**Bridge Factors Factual Report Attachment 26 – BPA Cracks Report No. 3 - Email from
Mr. Jose Morales of BPA to Mr. Rodrigo Isaza of MCM dated March 13, 2018**

HWY18MH009

Report # 3

From: Jose Morales
Sent: Tuesday, March 13, 2018 10:59 AM
To: Rodrigo Isaza
Cc: Rafael Urdaneta; Maria Christina Acosta; Carlos Chapman; Ernie Hernandez; Pedro Cortes
Subject: RE: FIU-UCPP - Stage 3 - Erection of Main Span

PHOTO 1: Diaphragm 2, Westside top view, crack

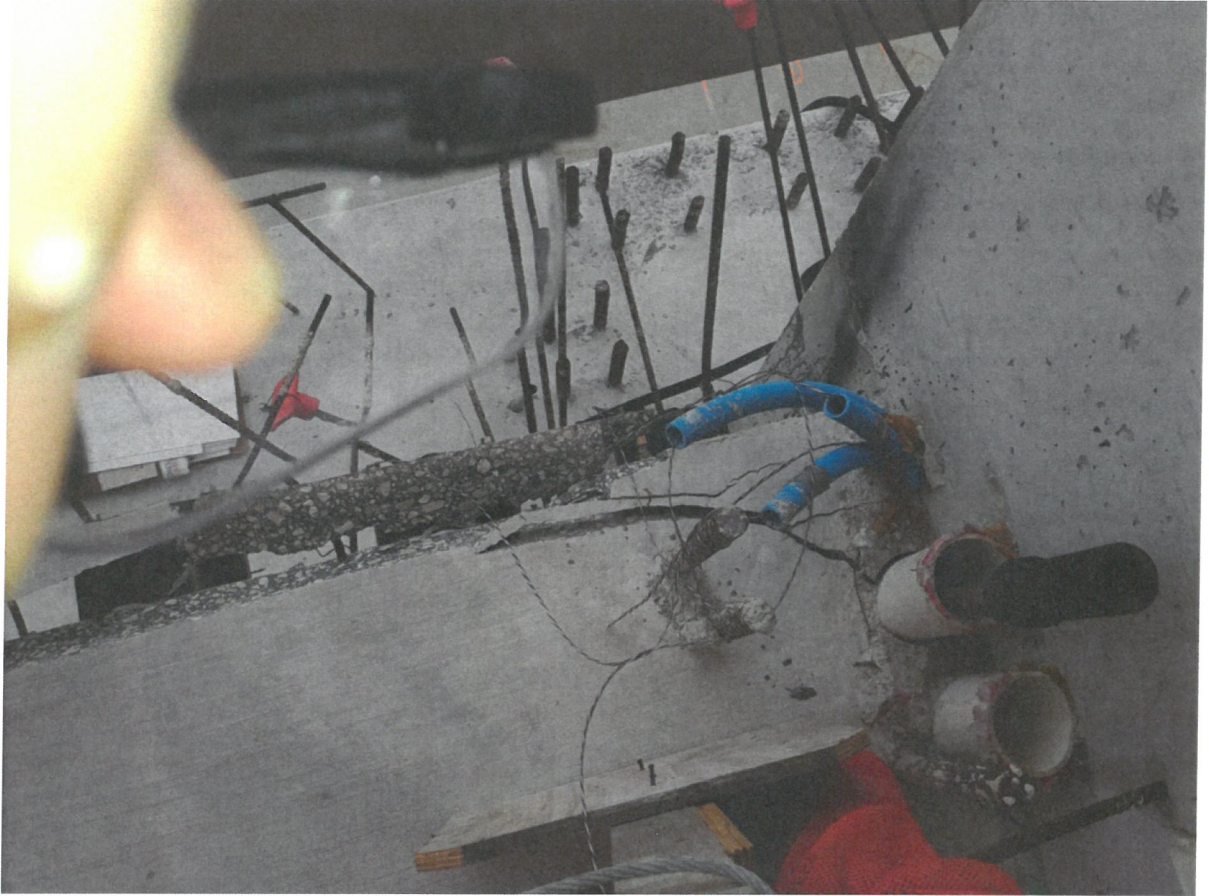
As discussed earlier, I recommend we monitor and document the growth of these cracks to determine if these are active and developing further or dormant.

Dwight,
Following our previous emails regarding the noted cracks, and as witnessed on site by FIGG as part of the movement/erection support, attached please find photos depicting the cracks developed prior and post the span 1 erection and/or distressing of truss members 2 & 11 (your team may have most of these pictures). It is our opinion that some of these cracks are rather large and/or of concern; therefore, please review and comment as promptly as possible and advise if there is a required course of action to remedy or address these right away.
